CONSTRUCTION INFRASTRUCTURE DRAWINGS  
**BROADMOOR**  
**CID-24-06**

**EROSION CONTROL  
 PLAN (STAGE 2)**

**C7.09**

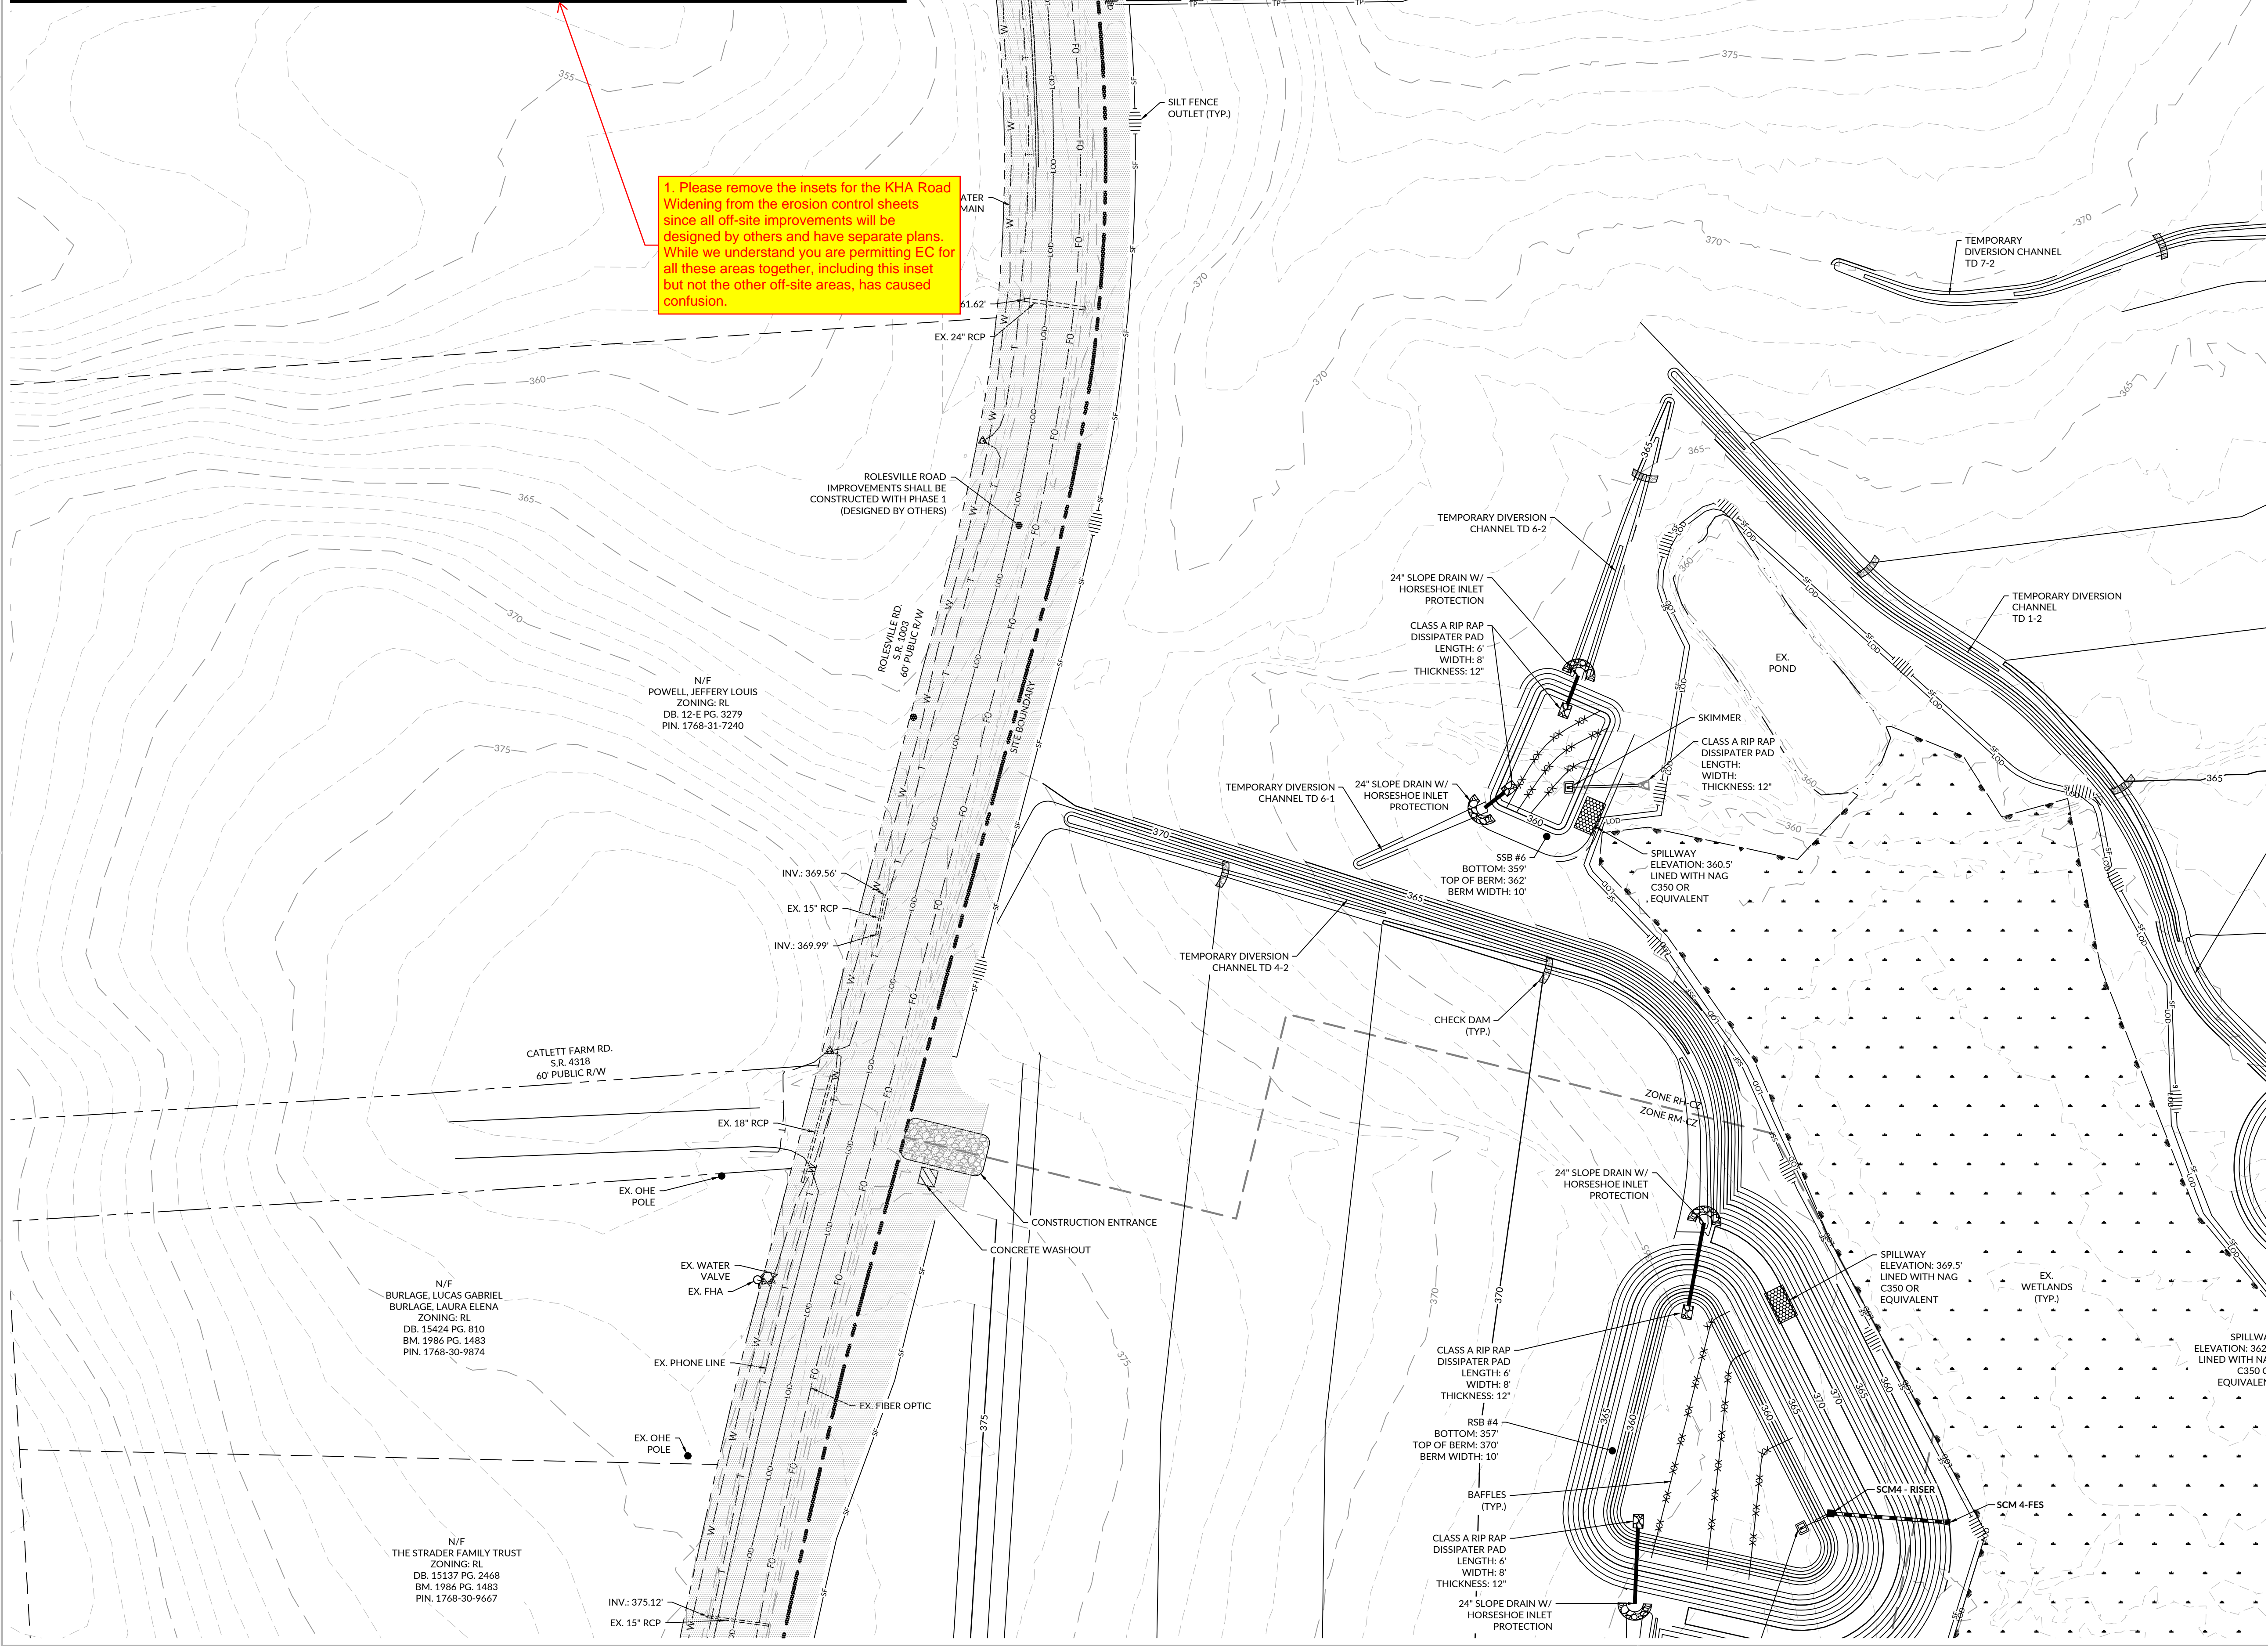
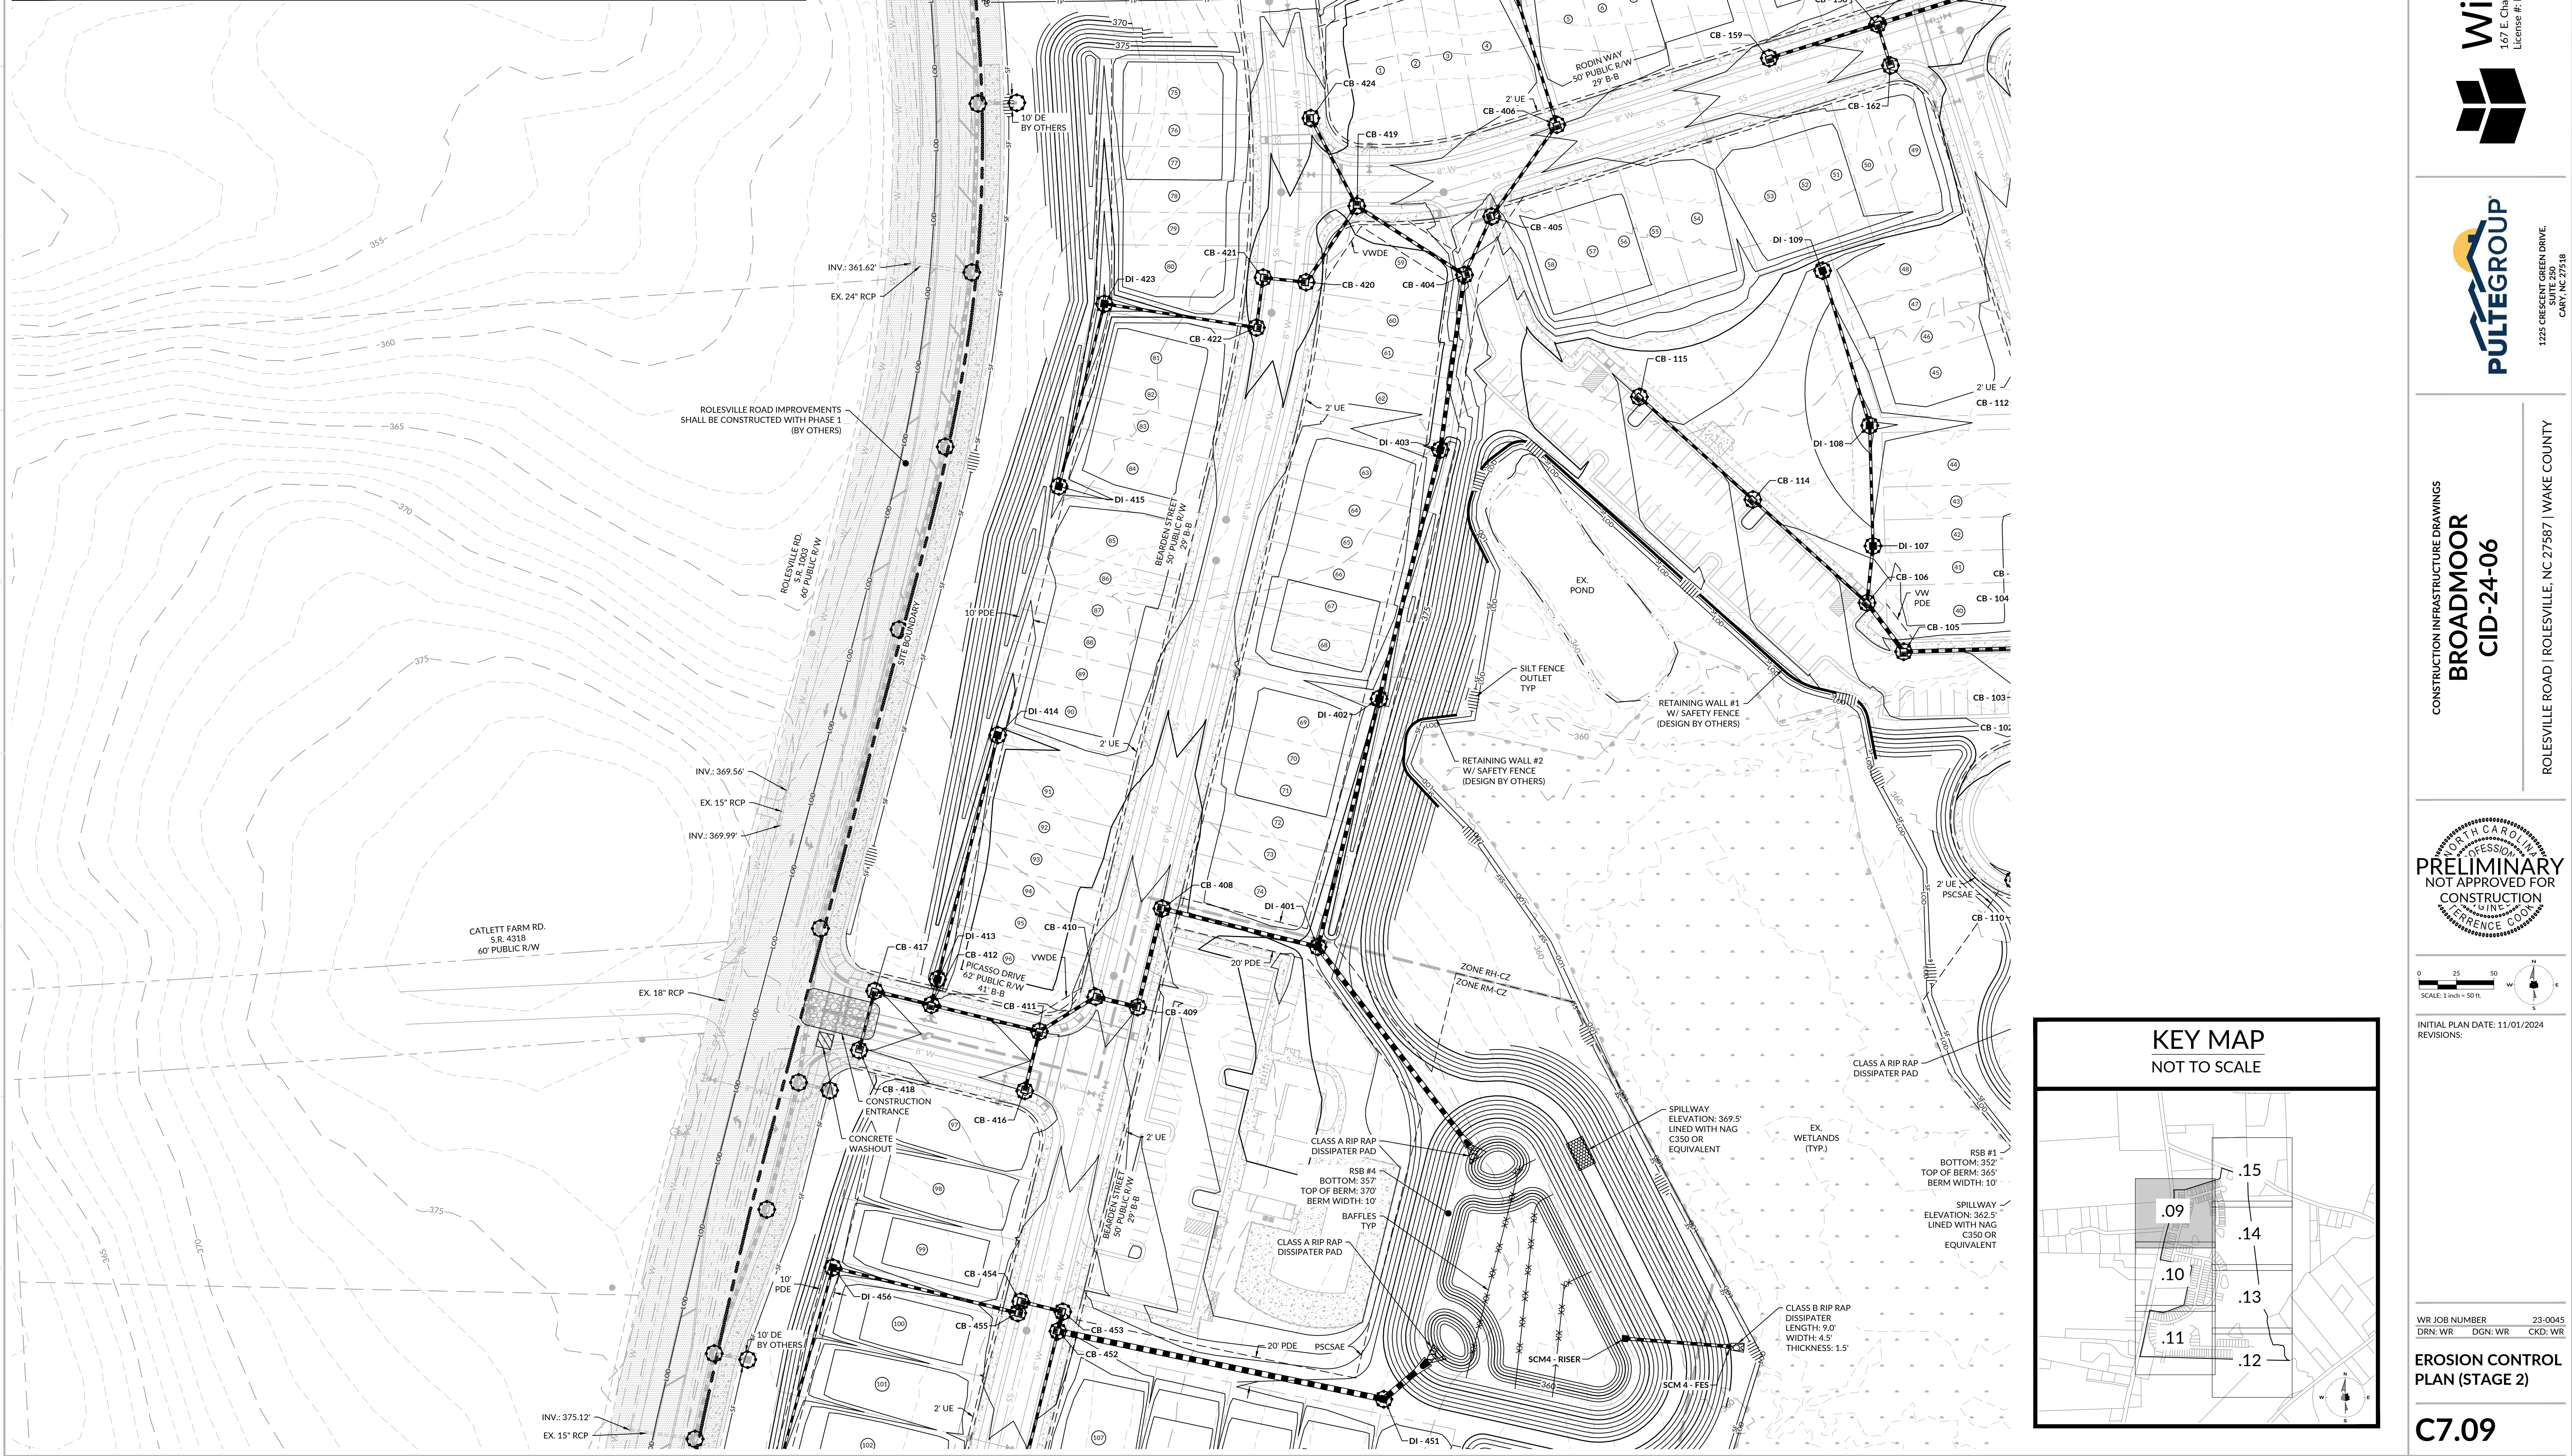
1. Please remove the insets for the KHA Road Widening from the erosion control sheets since all off-site improvements will be designed by others and have separate plans. While we understand you are permitting EC for all these areas together, including this inset but not the other off-site areas, has caused confusion.

**WET POND SCM #1 PLAN VIEW**  
SCALE: 1" = 30'

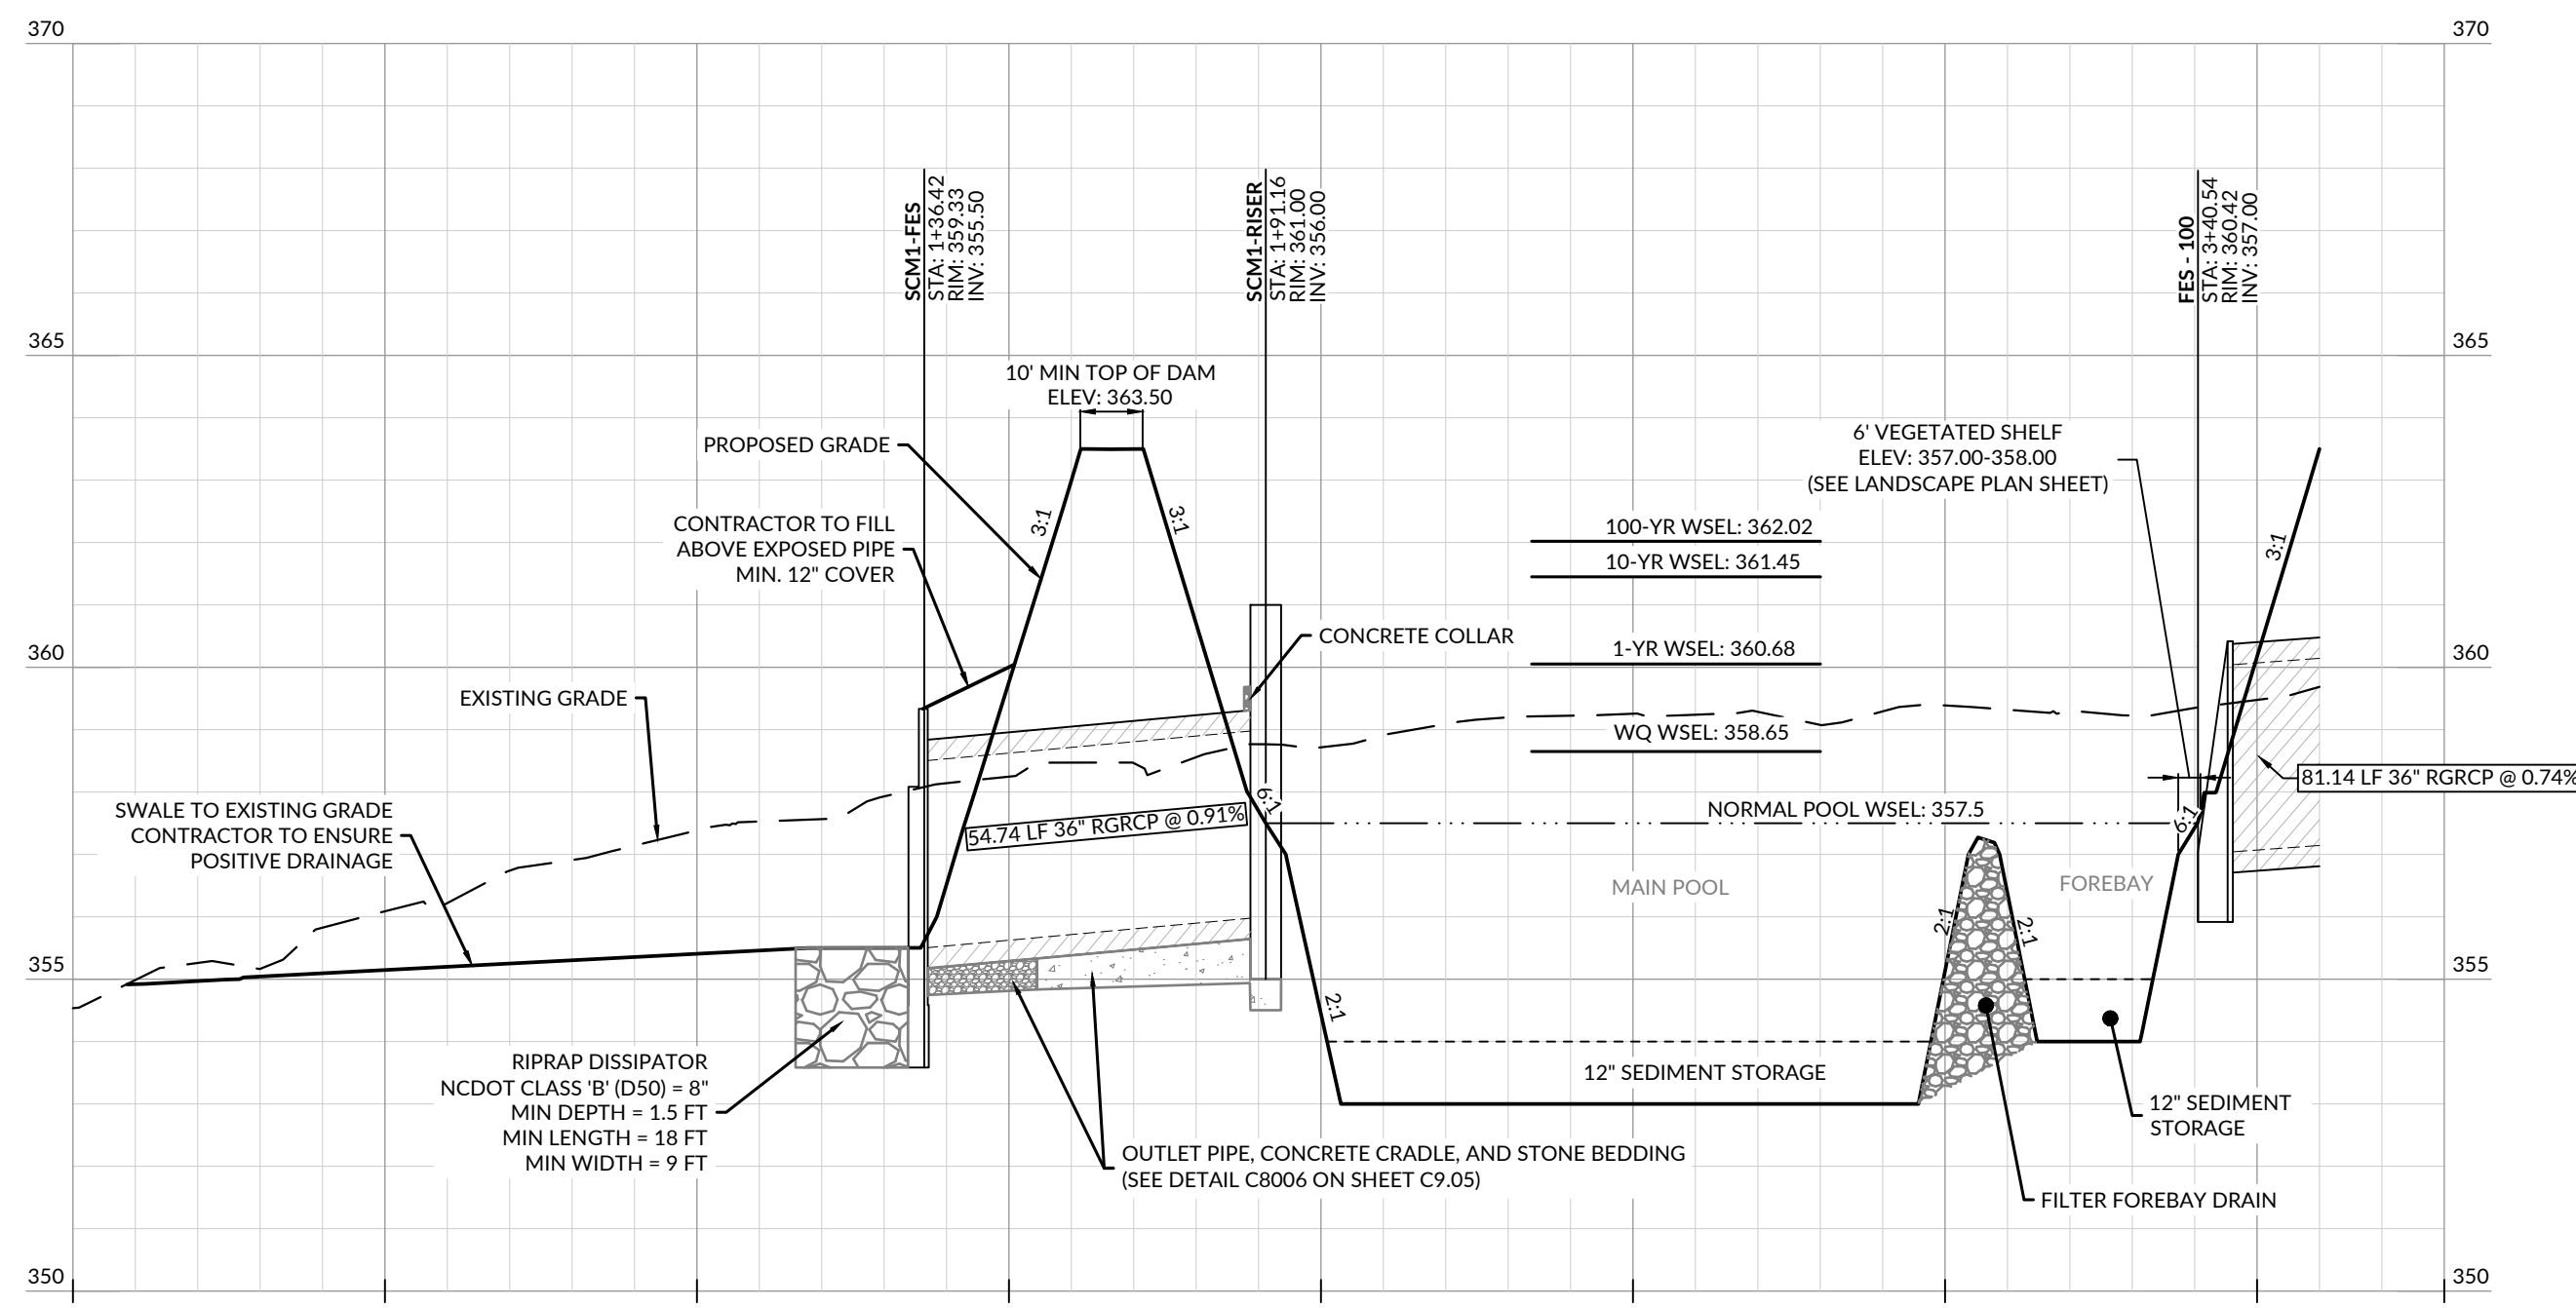
2. Add north arrow to plan view, typical.
